# UNITED STATES PATENT AND TRADEMARK OFFICE

## Office Action Summary

10/789,120

BADER, THOMAS

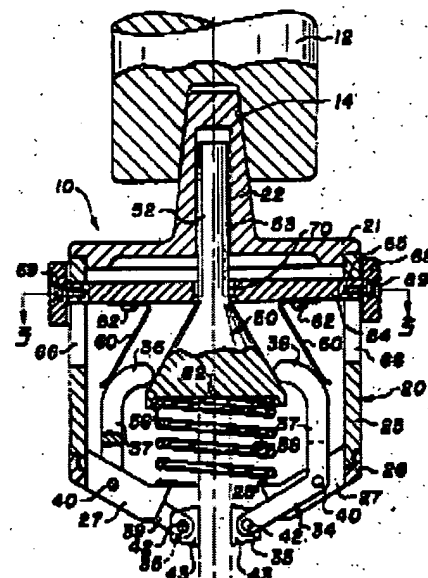
Regarding claim 19, the language as recited, i.e., lines 3-7, renders the claim indefinite. Specification as originally filed defines Fig. 2 as the support position (the clamping members abut the stem), but the claim states that upon upward application of force (opposite the 22, or towards the housing 6) "...from a support position thereof into a release position thereof", which is not according to the specification as filed, i.e., upward movement engages the stem not releases it.
